INDEX MAP  
 TRACT NO. 21539  
 SCALE 1"=400'  
 P.C. 4882

PROFILE ALIGNMENT AND GRADE OF P.C. 4882  
 SANITARY SEWERS PAGE 1  
 TO BE CONSTRUCTED IN  
 TRACT NO. 21539

PRIVATE CONTRACT NO. 4882  
 W.S. 27

28,959

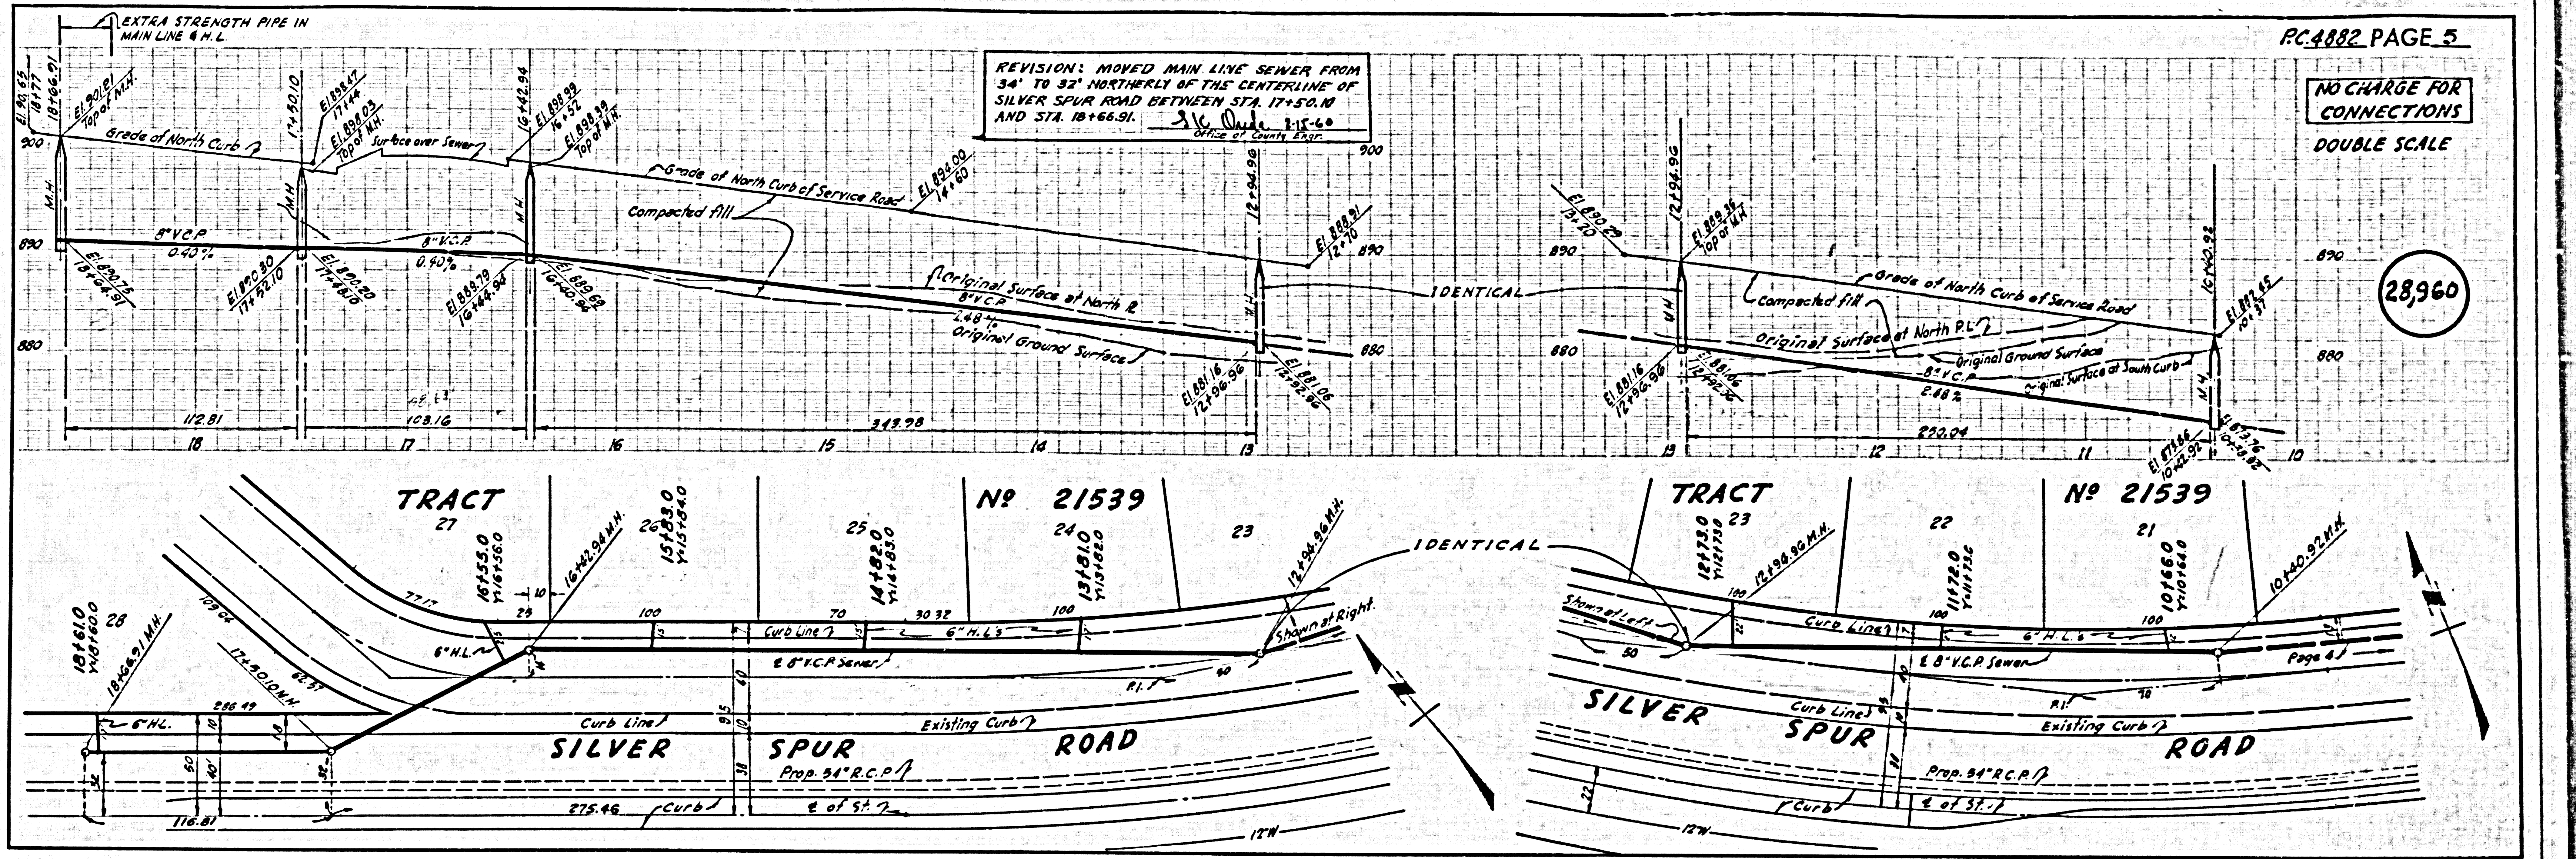
REGION OF 8" V.C.P. SEWER BETWEEN STATION 6+21.44 TO 7+76.44 IN SILVER SPUR RD. MOVED FROM 34' N. OF E. TO 32' N. OF E. - 1-15-64
